REDARC BMS1230S3 BMS1230S3R TVMSKIT05

PRODUCT UPDATE The Manager Range

The Manager range has changed to improve installation, reliability and bring the product into line with REDARC R-Bus standards.

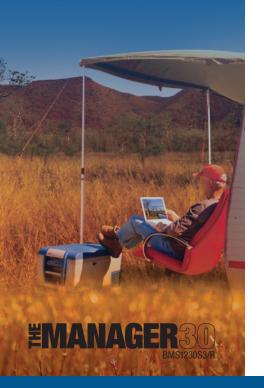
We've removed the T-Piece by adding a second R-Bus connection to the Main Unit. This will improve the reliability of the R-Bus connections in the Manager system.

We've also improved the Shunt by increasing the length of the R-Bus cable, changing the plug to RJ45 and adding an R-Bus terminating resistor. This means that the Shunt can now be installed further from the Main Unit, which is often a requirement in smaller trailers.

We have also created a variant of the Manager30 which comes with the new RedVision display. This provides an improved, 4.3" colour display as well as allowing connection of the Manager30 to the RedVision phone application.

Finally, we will be introducing the TVMSKIT05 which will be superseding the TVMSKIT04. The TVMSKIT05 combines the award-winning RedVision Total Vehicle Management System and the BMS1230S3 to provide full control and monitoring of a 4X4, camper, caravan or motorhome.
